Interactive comment on “Controls on root zone storage capacity in boreal regions” by Tanja de Boer-Euser et al.

Tanja de Boer-Euser et al.

Received and published: 20 June 2018

Fig. 1. Results of principal component analysis with variables compared to Sr. Top plot shows catchments in the three boreal regions

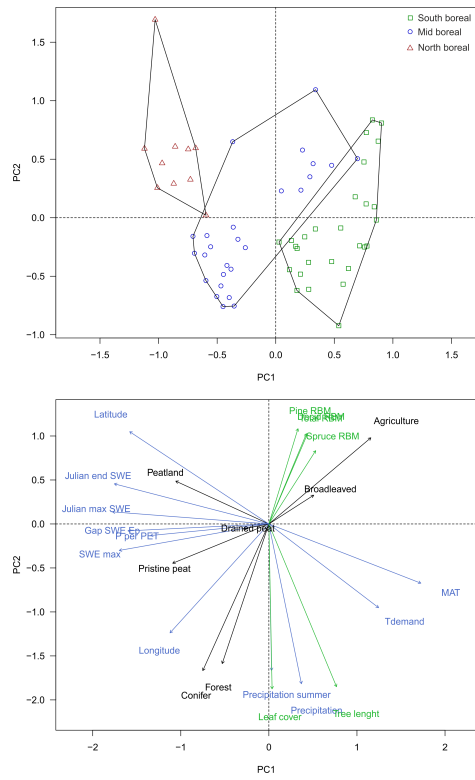
In this light, I think it would be more informative and would give more confidence in the results to apply some method which can account for a number of potential "controls" and assess their importance against each other, for example PCA or multimodel inference (e.g. Saft et al, 2016).

I am also a bit puzzled about the gap between snowmelt and onset of PET, as both are governed by exactly the same increasing energy flux (temperature/sunshine). I would assume that this gap should be very closely related to the maximum SWE (Ålǿjmore snow takes longer to melt). Anyway, it would be interesting to calculate this gap (using some threshold for snowmelt) and include it directly as yet another factor along with the other characteristics used. I wonder why it was treated separately.

Thank you for this suggestion; we think as well that the paper would benefit from such further elaboration. Both multimodel inference (as used by Saft et al., 2016) and PCA are useful methods for this. In line with our methodology, we will work this out further using the PCA. However, we do believe that the multimodel inference is very interesting when evaluating the possibilities to use climate derived S_r values to assess the effects of change.

The results of a PCA are presented in Figure 1, containing the different variables we

compared with S_r in the manuscript. As already expected, this analysis shows that the majority of the climate variables (shown in blue) are positively correlated and negatively correlated to the mean annual temperature and transpiration demand (which follows from the water balance). What can also be seen is the limited correlation between the majority of the climate variables and (summer) precipitation.

With respect to vegetation properties (shown in green), these are strongly correlated with forest and agricultural land covers, but limitedly correlated to the majority of the climate variables. Only peatland covers are positively correlated with the majority of the climate variables.

The plotted catchments (top plot) indicate that the eco-regions mainly differ in climate characteristics and that especially in the mid- and south boreal regions a large range of vegetation properties and land covers occur.

We will incorporate these results in a revised version of the manuscript.

The gap between snow-off and the start of E_p (measurements) is incorporated in the PCA presented in Figure 1. It can be seen this property is strongly positively correlated with the day and amount of maximum S_{SWE} .
